SUBJECT: NRC INSPECTION REPORT NO. 72-1004/2006-204 AND NOTICE OF VIOLATION

Inspection Report

Docket: 72-1004
Report: 72-1004/2006-204
Certificate Holder: Transnuclear, Inc.
7135 Minstrel Way, Ste. 300
Columbia, MD 21045

Transnuclear, Inc.
NRC Inspection Report 72-1004/2006-204

Figure 1 - Supplemental Shielding in Decontamination Area

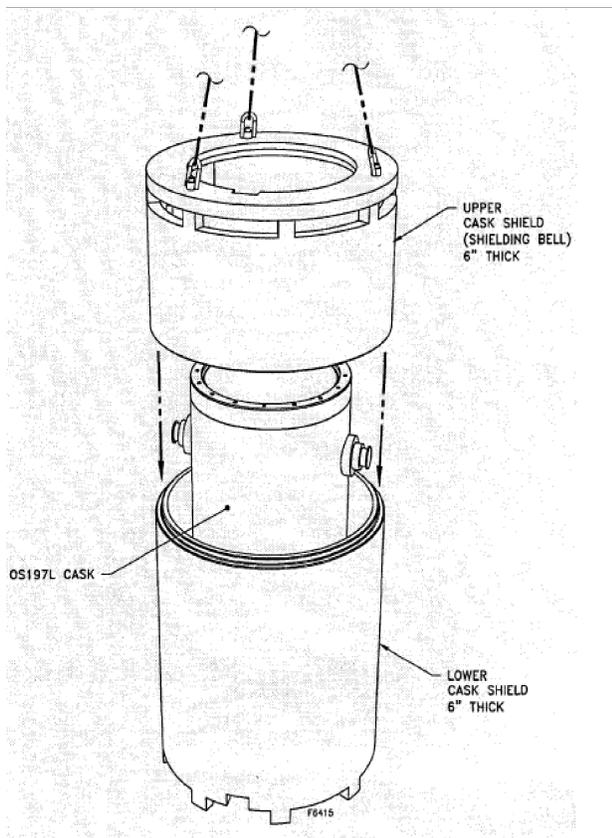
TN eliminated the lead shielding, and otherwise modified the OS197L TC design, to make the TC lighter. To compensate for the reduction of the shielding in the TC, TN provided additional temporary shielding in the decontamination area and on the transfer trailer. The additional temporary shielding is not present when the TC is lifted from the pool and moved to the decontamination area or when it is lifted from the decontamination area and placed on the trailer. TN's 72.48 analysis states, in part that the OS197L TC supplemental shielding, in conjunction with the OS197L bare cask body, provides a level of shielding that is similar to the OS197 TC.

Figure 2 - Supplemental Shielding on Transfer Trailer

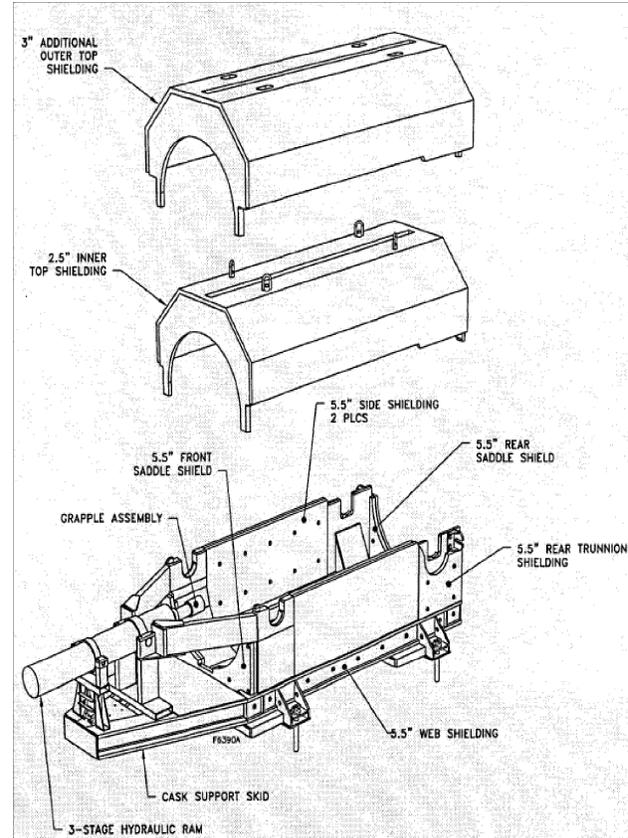
TN used the FLUENT Code Computational Fluid Dynamics (CFD) methodology to define boundary condition temperatures for the OS197L TC inside the supplemental shielding on the transfer trailer. Figure 2 in Section 1 of this Enclosure shows the transfer trailer supplemental shielding. The TC is placed inside this shielding when it is moved from the spent fuel pool building to the horizontal storage module. TN's position is that use of the FLUENT code is appropriate to model the natural convection driven air flow inside the shielding as it flows around the TC. The CFD analysis is performed modeling the cask and skid geometry including the air flow paths in the cask/skid shielding enclosure. The shielding enclosure is provided with openings between the skid beams and the trailer deck to allow air to enter the enclosure. Air exits the enclosure through an opening at the top of the enclosure.

The team, however, does not agree with TN's position that the AHSM methodology could be used to model a TC inside the transport trailer shielding. The team's position is that modeling a DSC inside an AHSM is different than modeling a DSC inside a transfer cask inside an AHSM. The team considers that the appropriate guidance in this case is contained in NEI 96-07, Appendix B, page 67, that states: "Similarly, licensees or cask certificate holders can also use different methods without first obtaining a license or cask CoC amendment if those methods have been approved by the NRC for the intended application." The team does not consider that the AHSM methodology was intended for the application that TN used it for; i.e., modeling a DSC inside a TC inside an HSM. The team also does not consider the DSC inside the TC inside the HSM to be adequately described as a cylinder within an enclosure, in that it is more accurately described as a cylinder, inside a cylinder filled with water, inside an enclosure.

The team considers that there are several geometry differences and modeling differences that led to the team's conclusion that TN's evaluation involved a change in method of evaluation. The geometry of the OS197L TC inside the supplemental shielding is different than the geometry of a DSC inside an AHSM. Differences between the geometries and how they affect the thermal methodology are listed in Table 1 below.
